CHANGE ORDER LOG

Project **LHS Campus _ Phase I**

Project: 24-055 - CITY OF LENOIR-CAMPUS IMPROVEMENTS
1114 COLLEGE AVE SW; 1116 College Ave SW; 1129 West Avenue
NW LENOIR, North Carolina 28645

Prime Contract Change Order #003: RFI #8: Gymnasium - Chimney Demolition Concealed Conditions

RFI 8.1

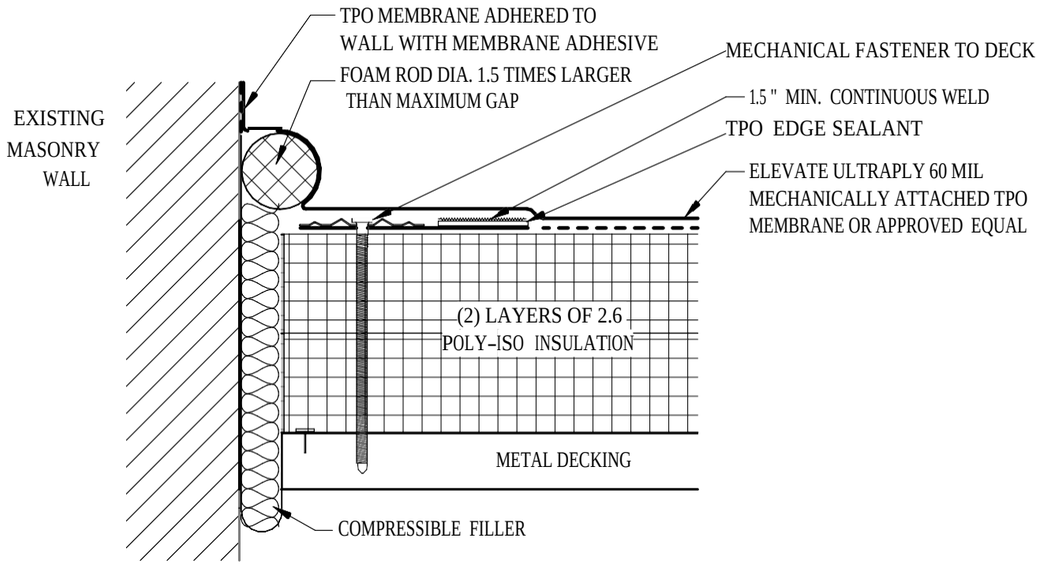
DESCRIPTION:
CE #010 - #8: Gymnasium - Chimney Demolition Concealed Conditions
The following change request is for the added wall furring, brick, and steel lintel needed due to the demolition of the existing chimney per drawings RFI 8.1 dated 3/3/2026, RFI 8.2 dated 3/3/2026, and SBD1 dated 3/17/2026.

1. New wall furring as shown on 1/RFI8.1, and per infill partition type schedule type, and painting of wall furring.
2. New Lintel per SBD1.
3. Brick Infill Per SBD1

RFI 8.2

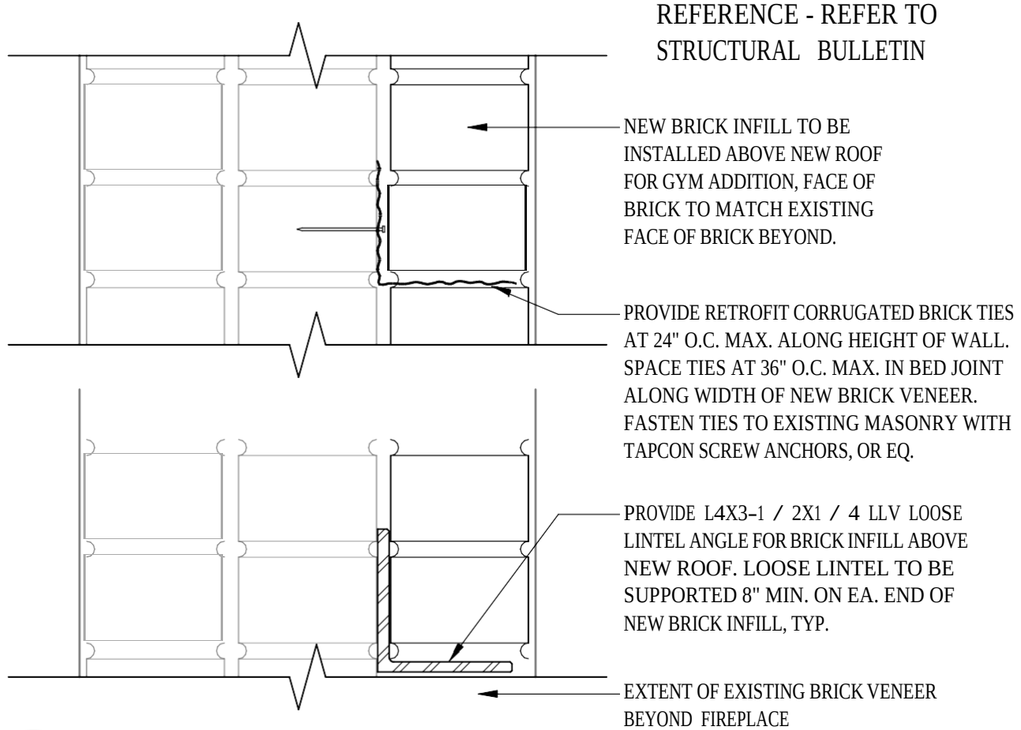
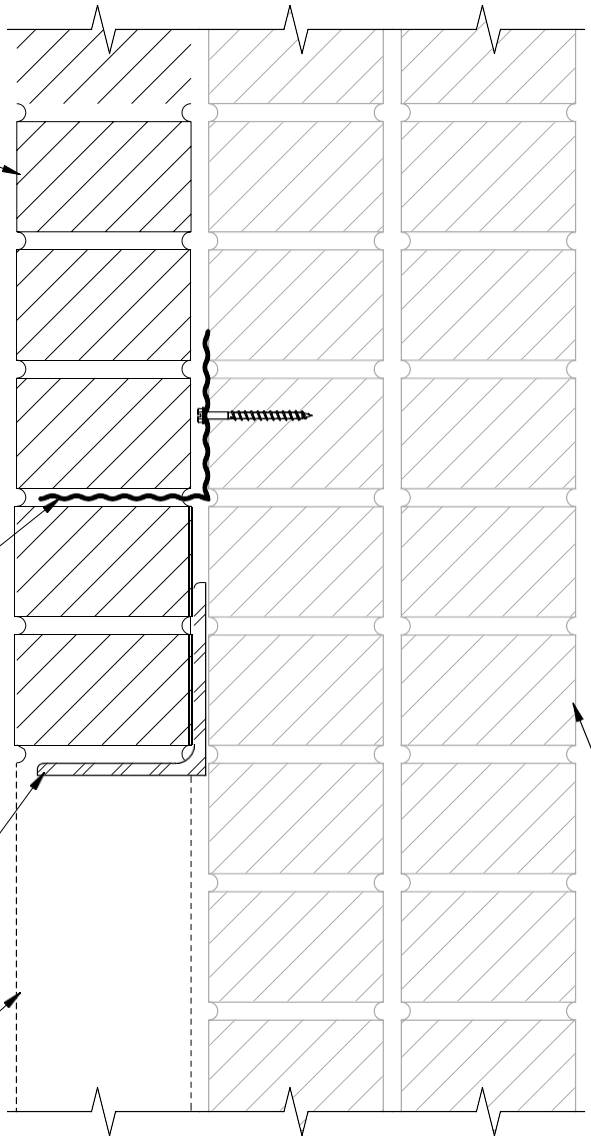
NEW BRICK INFILL TO BE INSTALLED ABOVE NEW ROOF FOR GYM ADDITION, FACE OF BRICK TO MATCH EXISTING FACE OF BRICK BEYOND. VERIFY HEIGHT OF NEW BRICK W./ARCH.

PROVIDE RETROFIT CORRUGATED BRICK TIES AT 24" O.C. MAX. ALONG HEIGHT OF WALL. SPACE TIES AT 36" O.C. MAX. IN BED JOINT ALONG WIDTH OF NEW BRICK VENEER. FASTEN TIES TO EXISTING MASONRY WITH TAPCON SCREW ANCHORS, OR EQ.

PROVIDE L4x3-1/2x1/4 LLV LOOSE LINTEL ANGLE FOR BRICK INFILL ABOVE NEW ROOF. LOOSE LINTEL TO BE SUPPORTED 8" MIN. ON EA. END OF NEW BRICK INFILL, TYP.

E1.0

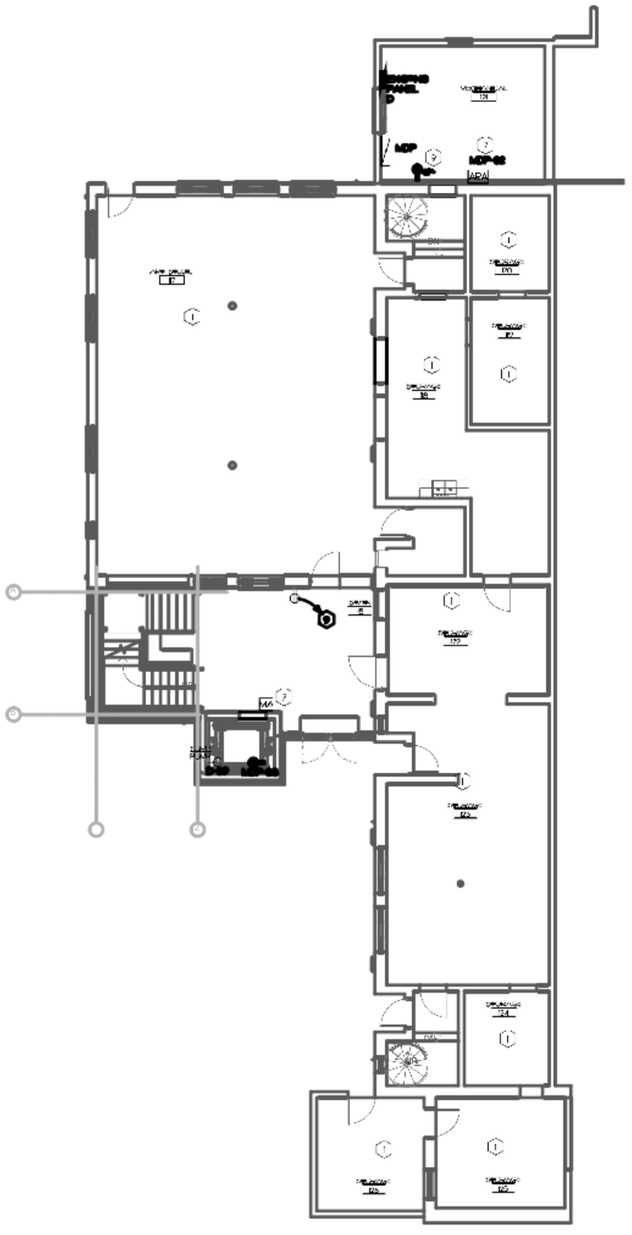
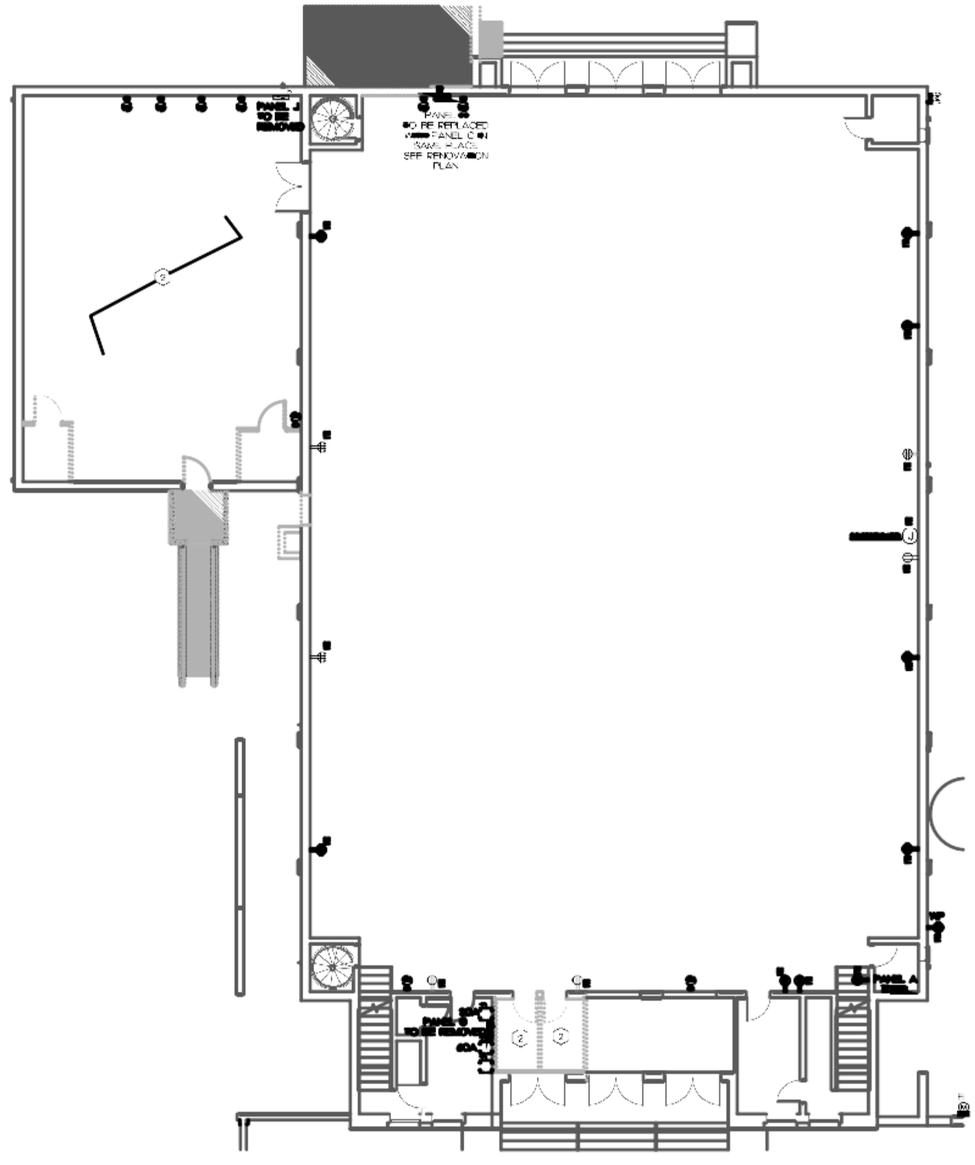
RFI 17: Basement Electrical Demolition:
RFI 17:
Currently E1.0 calls for the removal of all light fixtures, and devices in the old pottery room.
However due to the way the receptacles are being fed through the lights the removal of the lights will cause all but 1 receptacle to have new wiring ran to them.

RFI 15 & RFI 17 Responses Received:
E1.0: Replace existing receptacles with new in place. See renovation plan.
E1.1: Key Note 1 - Replace all existing receptacles in this area with new conductors to be in conduit.
E3.1: Revised Panel Schedule for Panel A
E3.2: Revised Panel Schedule for Panels

3 PHASE DEMOLITION POWER RISER

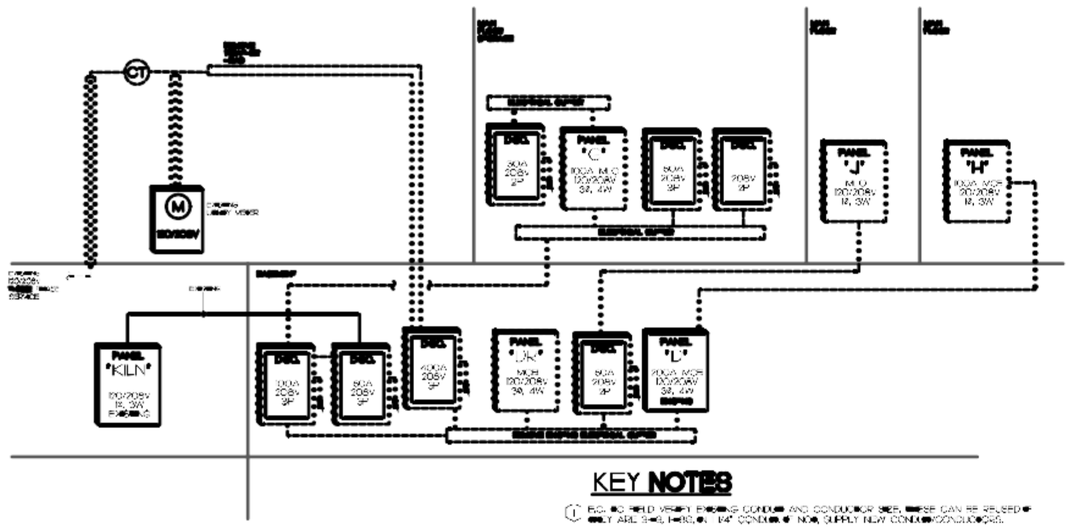
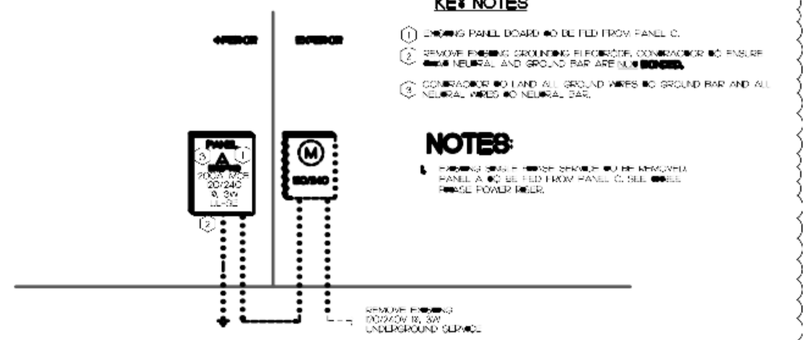
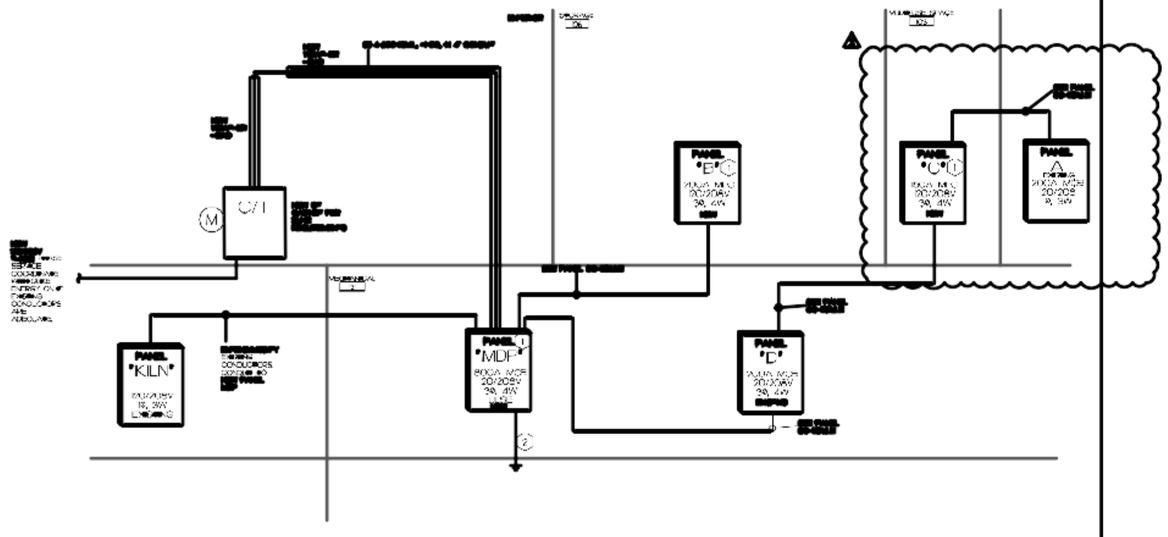
RFI 15: Fire Alarm:
RFI 15:
Owner has requested to remove the Panel A out of Room 009 in the plan south side of the building, and have everything included in Panel C in the plan north of the Contract Drawings.

Owner has requested to remove the panel A out of room 009 in the plan south side of the building, and have everything included in panel C in the plan north of the drawings.

Per discussions with ownership, we'll move forward with remove the additional electrical service. Will refeed panel A from panel C. Service will be close to capacity, but can add additional panel in future if need arises.

1. EXISTING PANEL BOARD TO BE FED FROM PANEL C.
2. REMOVE EXISTING GROUNDING ELECTRODE CONDUCTOR TO ENSURE [illegible] NEUTRAL AND GROUND BAR ARE NOT BONDED.
3. CONDUCTOR TO LAND ALL GROUND WIRES TO GROUND BAR AND ALL NEUTRAL WIRES TO NEUTRAL BAR.

1. EXISTING SERVICE SHOULD BE REMOVED. PANEL A TO BE FED FROM PANEL C. SEE SINGLE POWER RISER.

1012.2 Slope.

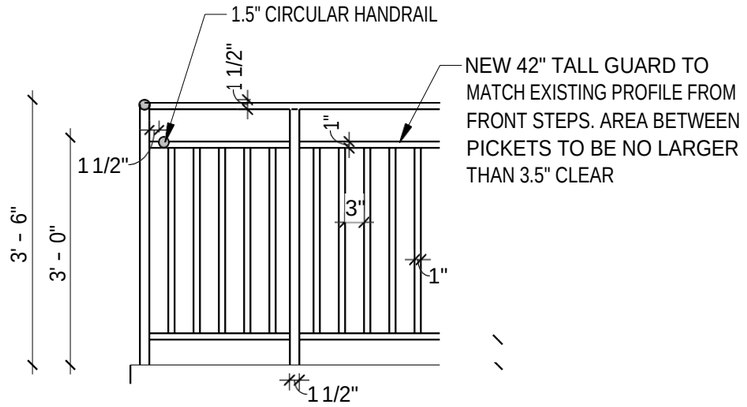
On the exterior of the building we're adding a ramp for prop load-in, load out only. It's not a required means of egress. Section 1012.2 of NCBC below allows for non egress ramps to have a slope of 1:8. Our ramp slope will be 1 1/8":12.

Ramps used as part of a *means of egress* shall have a running slope not steeper than one unit vertical in 12 units horizontal (8-percent slope). The slope of other pedestrian *ramps* shall not be steeper than one unit vertical in eight units horizontal (12.5-percent slope).

I received your text yesterday regarding approval to move forward without the wheelchair lift at the auditorium. We'll plan to move forward without the wheelchair lift and at the exterior non egress ramp steeper than 1:12 slope. Thanks for the time!

1 REVISED RAMP PLAN

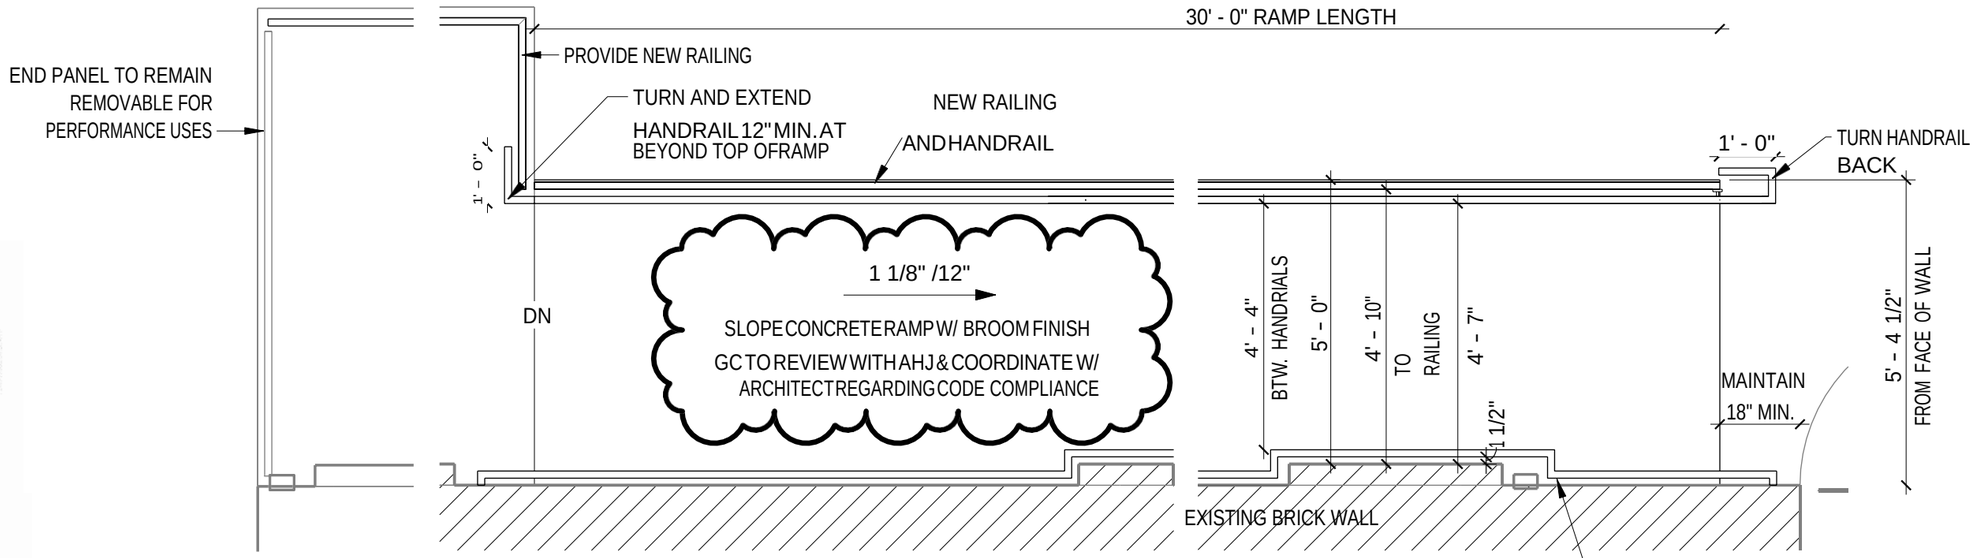
DESCRIPTION:
CE #018 - RFI #14: Auditorium - ADA Elevator Access and Ramp
Change Order is for eliminating the wheel chair lift inside of the auditorium, and increasing the size of the exterior ramp as shown in the B-1 bulletin drawing "Exterior Ramp Revision".

Change order also includes revisions to hand rail by removing remaining existing rail as shown on B-1 and additional railing length and new profile to include pickets spaced no larger than 3.5".

Proposed bulletin drawing attached showing maximum length of auditorium exterior ramp.

SHEET: S1.4

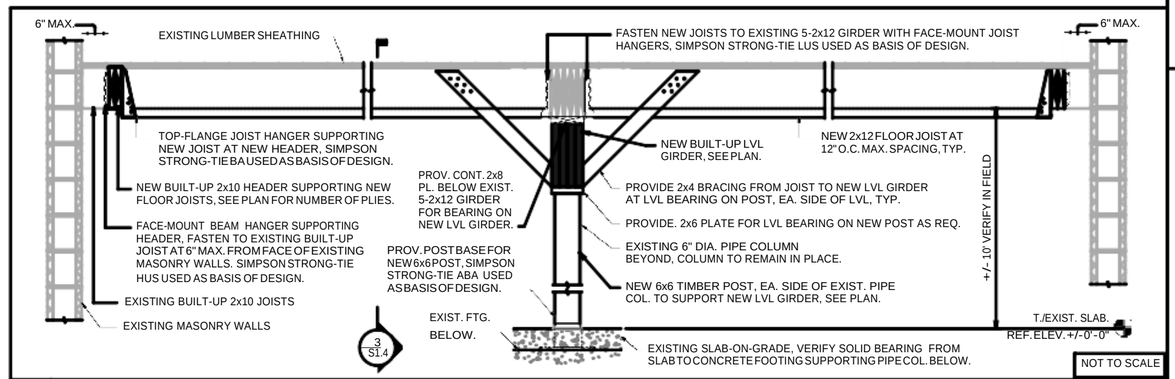
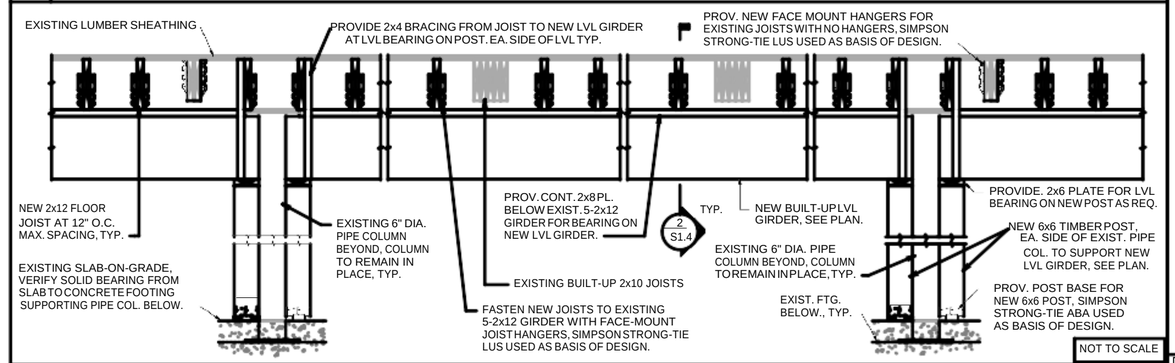
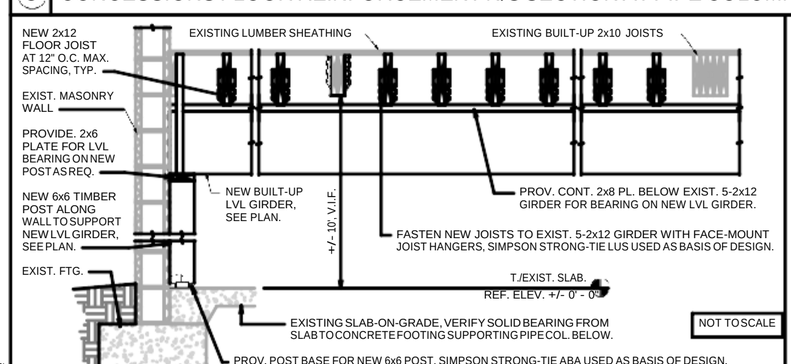
DESCRIPTION:
CE #031 - Concession Floor Reinforcement
Due to existing structural floor support conditions, and lack of support for the expected live and dead loads additional flooring support is required to meet 80 PSF. This change order is for the following:

Description of change:
Pottery Area LVLs and joist per structural concession floor plan Sheet S1.4

3. THE EXISTING LUMBER GIRDER SHALL BEAR SOLID ON THE NEW LVL GIRDERS. PROVIDE SHIMS AS REQUIRED TO ACHIEVE SOLID BEARING, SEE TO SECTIONS.
4. CONTRACTOR SHALL VERIFY ALL EXISTING CONDITIONS AND DIMENSIONS REQUIRED. ANY DISCREPANCIES BETWEEN FIELD CONDITIONS AND THESE DOCUMENTS SHALL BE REPORTED TO AVERY ENGINEERING PRIOR TO CONSTRUCTION.
